CURVE LAKE FIRST NATION

LOT 12 & 13 SUBDIVISION – ROAD CONSTRUCTION TENDER

March 20, 2020

Addendum 1

ROLLIE'S POINT ROAD CROSS-SECTION A-A

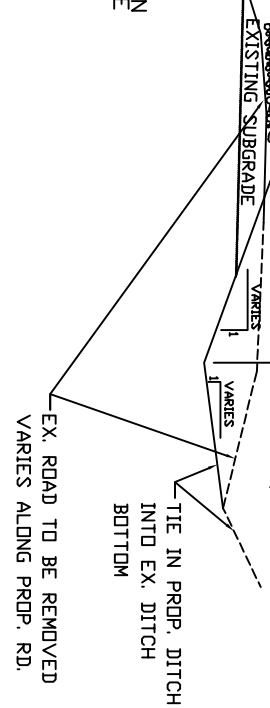
3. The road cross section shown on drawings RD 100 and RD 102 will be replaced by the cross section below which is for a 6.8m paved width.
4. The Culverts are to be corrugated steel pipe with a minimum 2.4 wall thickness.

40mm MIN. ASPHALT HL3
 60mm MIN. ASPHALT HL8
 150mm MIN. GRANULAR A
 350mm MIN. GRANULAR B
 NON-WOVEN GEOTEXTILE
 APPROVED SUBGRADE
